**SERVICE  
BULLETIN**

1. Issue Date : **September 30, 2016**
2. Bulletin number : **02/09/2016**
3. Subject : **m2 AAD Cutter Replacement**
4. Status : **Mandatory**
5. Identification : **Identification of affected m2 AAD cutters**

Fig.1

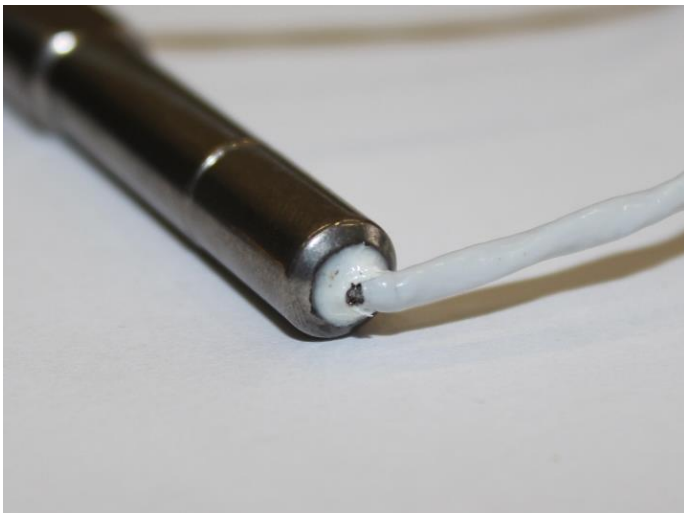
The cutter cable insulation has cracked on some MarS m2 AAD cutters as shown in Fig. 1. Investigation by the manufacturer has shown that this is caused by the method used to close and seal the cutter body. The cracking only affects the insulation, and the function of the device is unaffected. However, as a precaution, all cutters that are affected by this bulletin must be replaced.

a. If a problem exists with the cutter this will be detected by the control unit and displayed as an error No.2. In this case, the cutter must be replaced immediately.

b. If no error is detected, then the AAD may remain in use until the next repack cycle. During the next regular repack the cutter must be inspected and replaced if it is affected by this bulletin.
